# Technical Announcement

Delta Electronics, Inc. IABG

Product	ASDA-A3	Applicable Model	A3-M A3-F A3-E A3-L	Security Classification	<input checked="" type="checkbox"/> General <input type="checkbox"/> Confidential <input type="checkbox"/> Highly Confidential
				ECN No.	126A-18B010 126A-19C012
Issued by	ASD	Author	Chloe Chen	Issue No.	ASD20060400
				Release Date	June 4, 2020
Recipient	Sales Representative (Taiwan), Product Manager (Taiwan), DGC, DEU, DPR, DES, DEK, DEJ, and DIN

Firmware update release for the ASDA-A3 series products.

21. Added P1.060 Motor hard stop 1 - level offset.

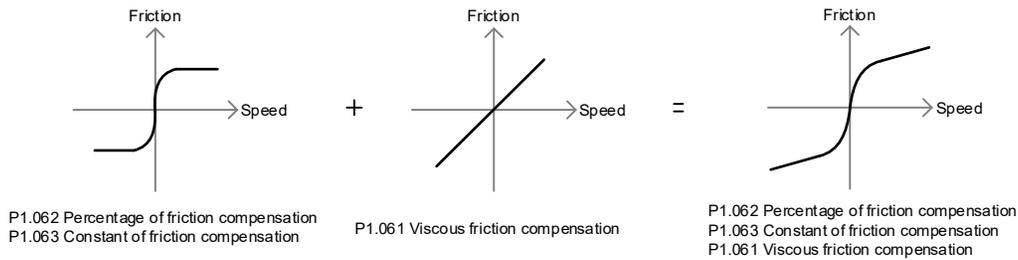
When using P1.057 (Motor hard stop 1 - torque percentage) and the average torque level deviates due to an external force, such as Z-axis gravity, you can use this parameter to set the corresponding compensation.

Suggested setting value = (Average torque at constant speed in positive direction + Average torque at constant speed in negative direction) / 2

### 26. Added P1.084 Error clearing function when switching between full- and semi-closed loops.

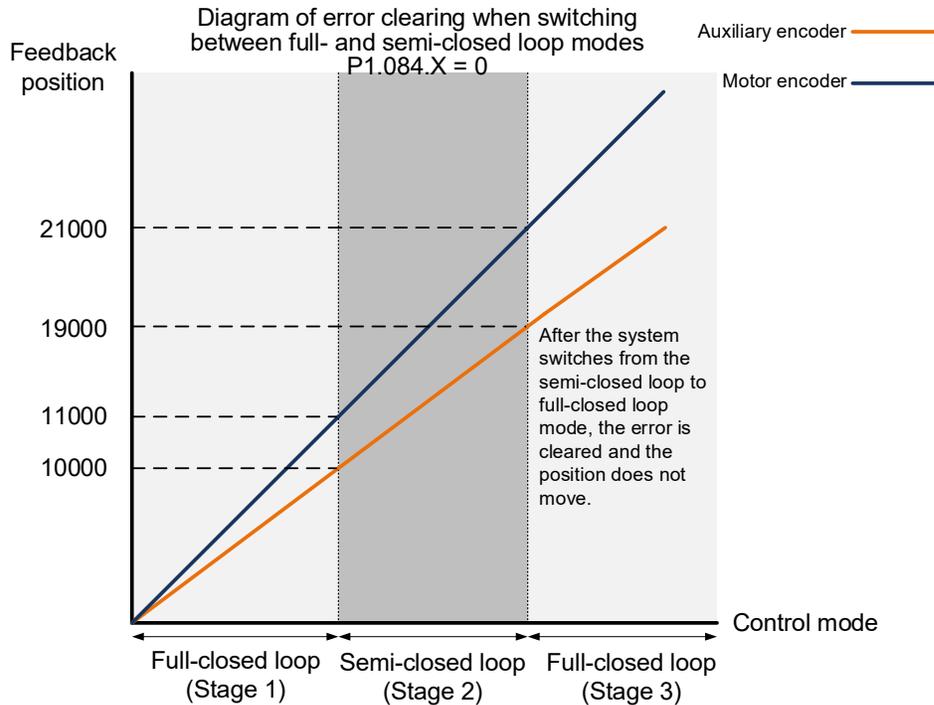
X	Error clearing function when the system switches from semi-closed loop to full-closed loop	Z	Reserved
Y	Reserved	U	Reserved

- X:** error clearing function when switching from semi-closed loop to full-closed loop  
 0: clear the error when switching.  
 When the system is in semi-closed loop control, the command refers to the motor encoder, and the position does not move after the system switches to full-closed loop.  
 1: no clearing of the error when switching.  
 When the system is in semi-closed loop control, the command refers to the motor encoder. After the system switches to full-closed loop, the command issued in semi-closed loop becomes the full-closed loop command, thus the position moves.

- Error clearing enabled (P1.084.X = 0)

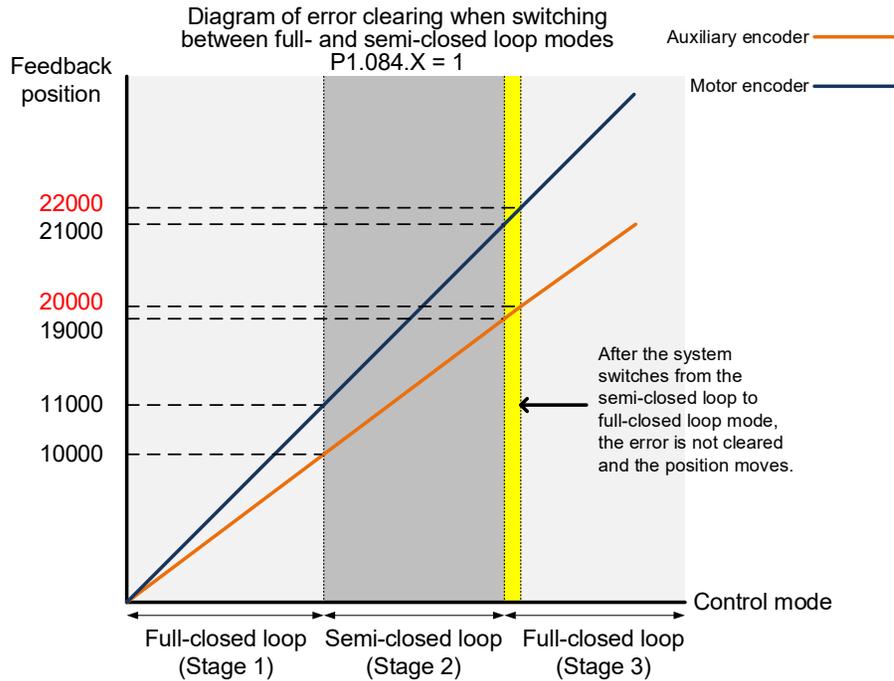
**Stage 1: full-closed loop control (feedback position of the auxiliary encoder)**

If the servo drive issued a position command of 10,000 PUU and the feedback position of the auxiliary encoder is 10,000 PUU, the final feedback position of the motor encoder is 11,000 PUU due to the backlash and sliding of the mechanism.

**Stage 2: semi-closed loop control (feedback position of the motor encoder)**

Use DI [0x0B] to switch the control mode from full-closed loop to semi-closed loop, then issue the position command of 10,000 PUU again. In semi-closed loop control, since the command refers to

the position of the motor encoder, the final feedback position of the motor encoder is 21,000 PUU, but the feedback position of the auxiliary encoder is 19,000 PUU. In this mode, there is an error of 1,000 PUU between the auxiliary encoder (19,000 PUU) and the position command (20,000 PUU).

**Stage 3: full-closed loop control (feedback position of the auxiliary encoder)**

When you set P1.084 to 0, the error will be cleared. Thus, after using DI [0x0B] to switch the control mode from semi-closed loop to full-closed loop, the feedback position of the auxiliary encoder is not corrected.

- Error clearing disabled (P1.084.X = 1)

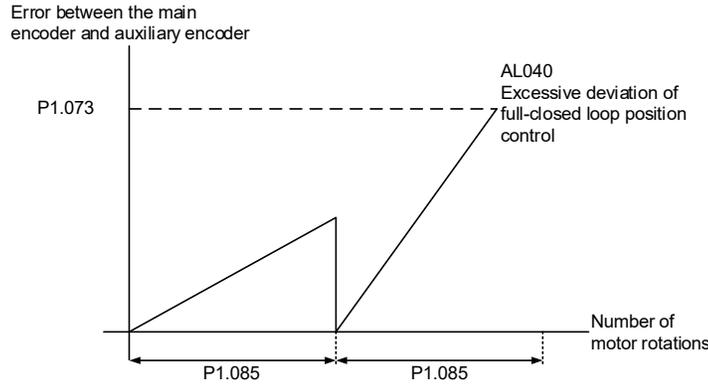
**Stage 1: full-closed loop control**

If the servo drive issued a position command of 10,000 PUU and the feedback position of the auxiliary encoder is 10,000 PUU, the final feedback position of the motor encoder is 11,000 PUU due to the backlash and sliding of the mechanism.

**Stage 2: semi-closed loop control**

Use DI [0x0B] to switch the control mode from full-closed loop to semi-closed loop, then issue the position command of 10,000 PUU again. In semi-closed loop control, since the command refers to the position of the motor encoder, the feedback position of the motor encoder is 21,000 PUU, but the feedback position of the auxiliary encoder is 19,000 PUU. In this mode, there is an error of 1,000 PUU between the auxiliary encoder (19,000 PUU) and the position command (20,000 PUU).

**Stage 3: full-closed loop control**

When you set P1.084 to 1, the error will not be cleared. Thus, after using DI [0x0B] to switch the control mode from semi-closed loop to full-closed loop, the feedback position of the auxiliary encoder is corrected and the motor moves to the corresponding position (yellow area as shown in the above figure). The previous semi-closed loop command becomes the full-closed loop command and refers to the auxiliary encoder to move the mechanism to the position corresponding to the actual command. The final feedback position of the auxiliary encoder is 20,000 PUU.

28. Added P1.105 Motor hard stop 2 - torque upper limit.

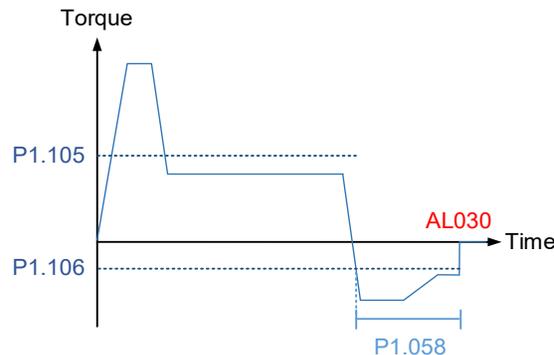
When Motor hard stop 2 is enabled (P2.112.bit 8 = 1), the settings of torque percentage (P1.057) and level offset (P1.060) for Motor hard stop are invalid. During motor operation, if the motor current is higher than this protection setting value and continues in this state exceeding the protection time (P1.058), AL030 will be triggered.

**P2.027.X = 4**

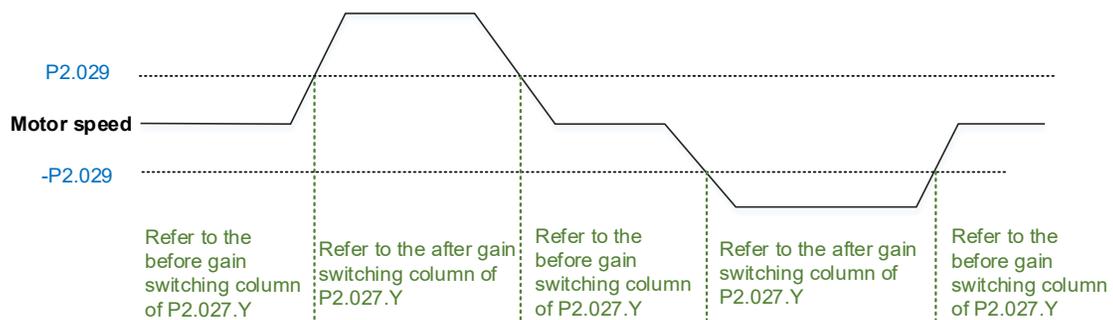
When P2.027.X is set to 1, 2, 4, 5, 6, or 8, P1.078 Gain switching delay time is not supported.

**P2.027.X = 3**

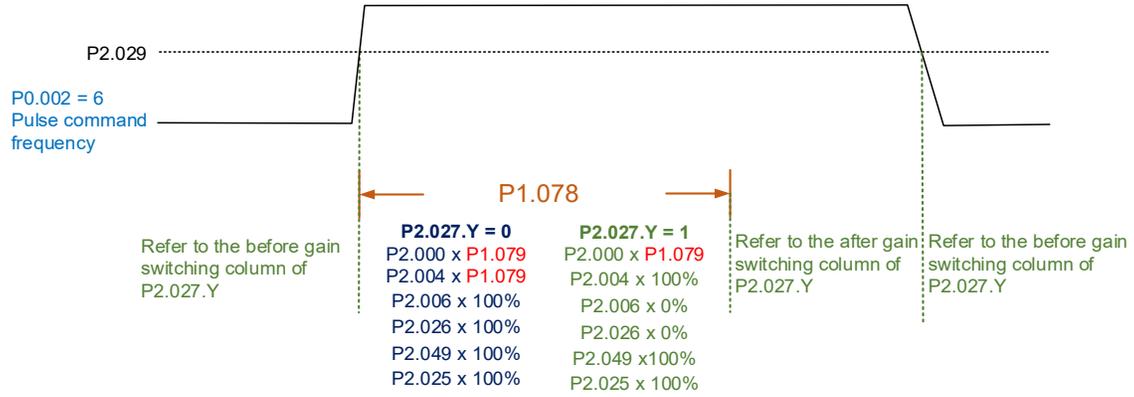
When P2.027.X is set to 3 or 7 and P1.078 Gain switching delay time is set, the servo drive ignores the setting value of P2.027.Y. The gain parameter during the delay time is adjusted according to P1.079. Refer to the following figure.

### 54. Added P4.044.X Single-direction torque limit setting.

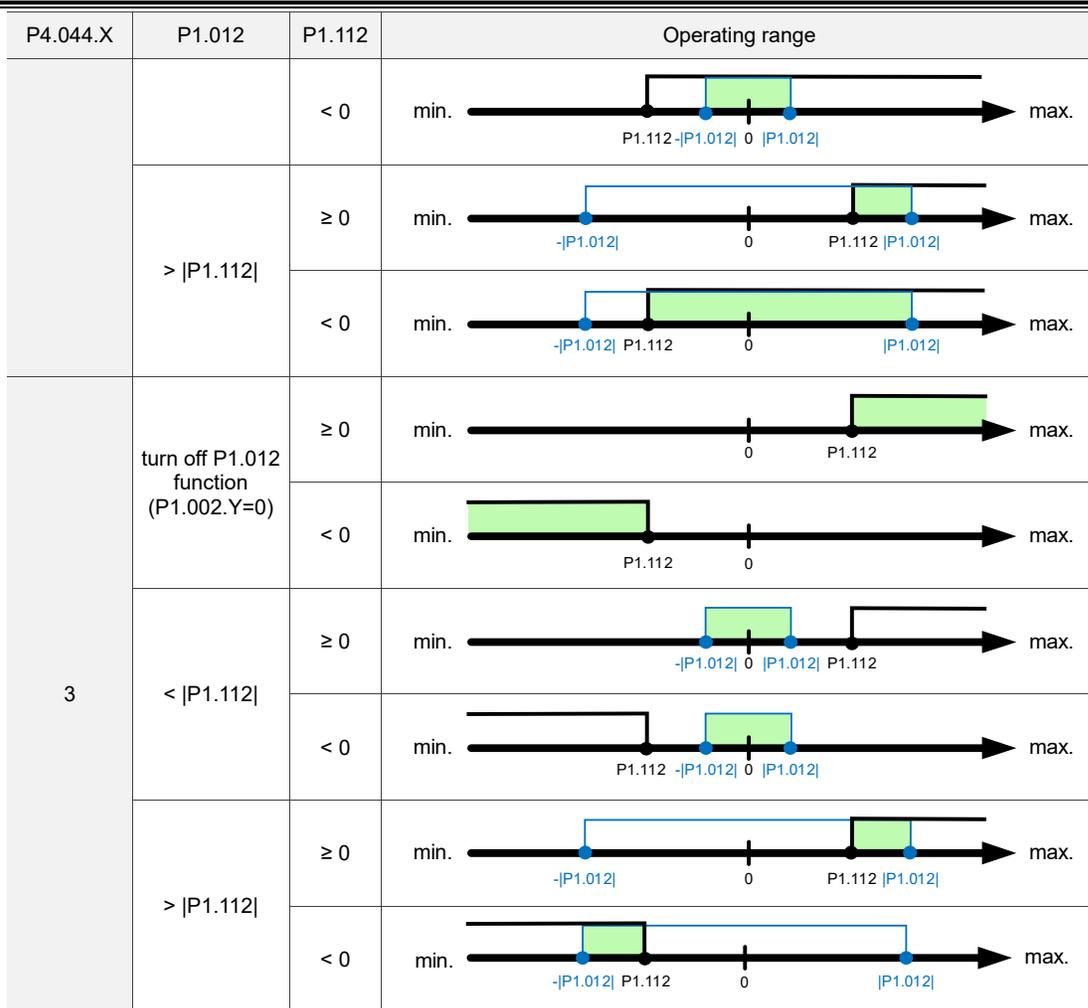
X	Single-direction torque limit setting	Z	Reserved
Y	Reserved	U	Reserved

This parameter limits the torque of the motor. The area with the background color is the torque limit area.

The following figures use P1.012 to explain the settings, but the functions of the External analog torque command and Internal torque limits(P1.012~P1.014) are the same, so you can set these parameters according to the requirements.

## 61. Added PM.006 Motor UVW and Hall sensor phase sequences.

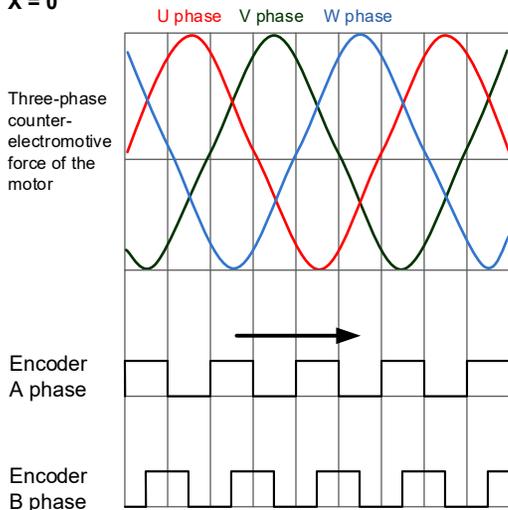
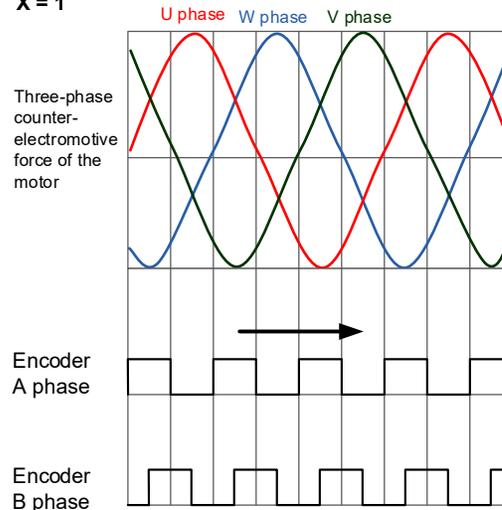
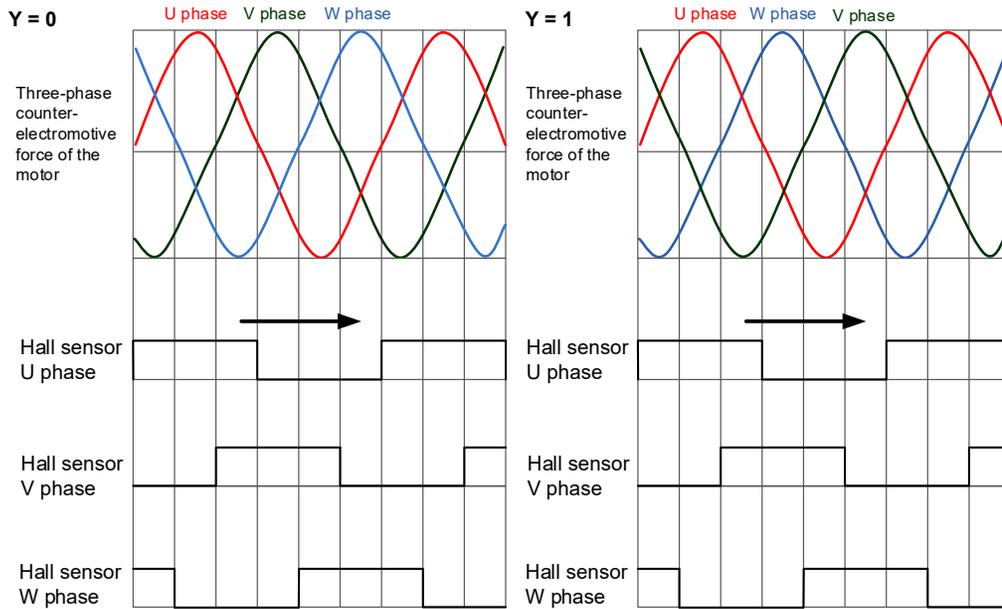
**X = 0**

**X = 1**

- Y:** motor UVW phase sequence and Hall sensor UVW direction  
 0: when the Hall sensor phase sequence is U, V, and W, the motor phase sequence is U, V, and W.  
 1: when the Hall sensor phase sequence is U, V, and W, the motor phase sequence is U, W, and V.

## 62. Added PM.007 Hall sensor offset angle.

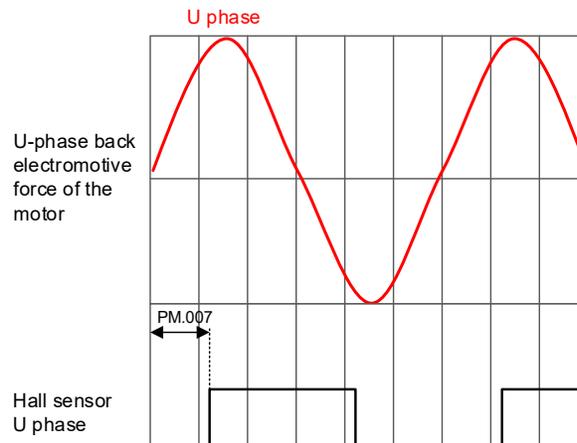
During the motor parameter identification process, the servo drive automatically detects the offset angle of the Hall sensor. You can use this parameter to obtain this information.

When the Hall sensor causes hysteresis due to different motion directions of the motor, the U-phase zero point of the Hall sensor is based on the central angle of the hysteresis. For the description of hysteresis, refer to the diagram of PM.008.

### 63. Added PM.008 Hall sensor hysteresis width.

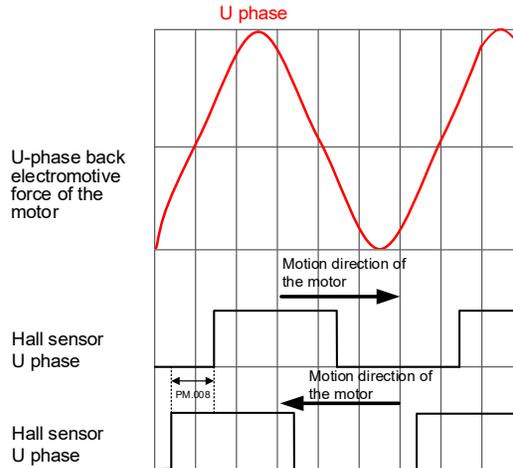
During the motor parameter identification process, the servo drive automatically detects the hysteresis width of the Hall sensor. You can use this parameter to obtain this information.

## 71. Added PM.019 Load increase gain.

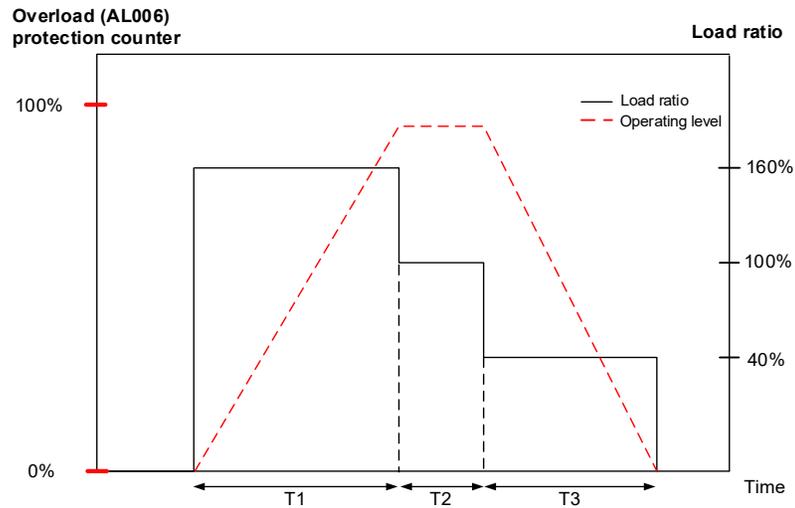
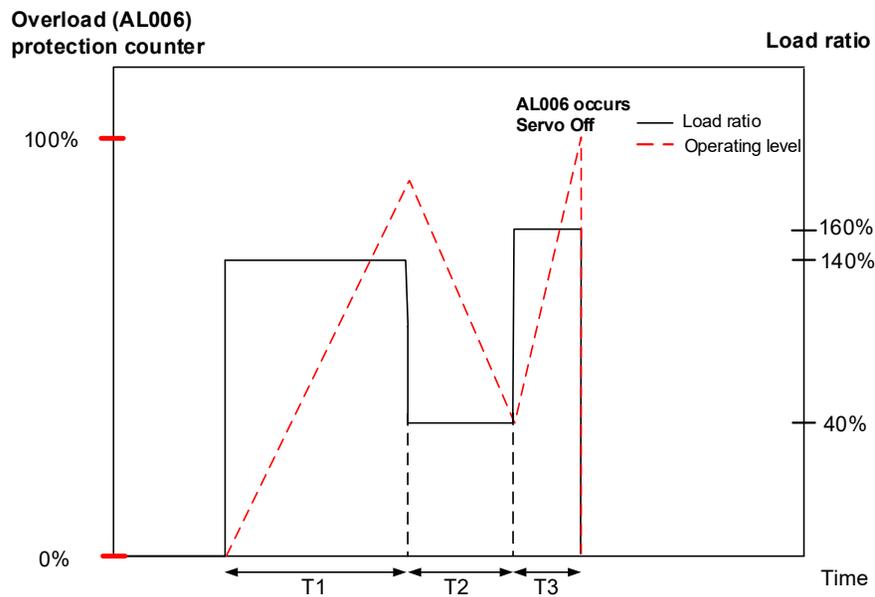
Use this parameter to adjust the motor overload protection time. For the setting details, refer to the following table and figures.

1. When the load ratio is 160%, the overload (AL006) protection counter continues to increase.
2. When the load ratio is 100%, the operating level is leveled off.
3. When the load ratio is 40%, the overload (AL006) protection counter continues to decrease.

As shown in the figure above, the load ratio affects whether the load is accumulated. When the load accumulates over 100%, the operating time must be taken into consideration, or else AL006 occurs.
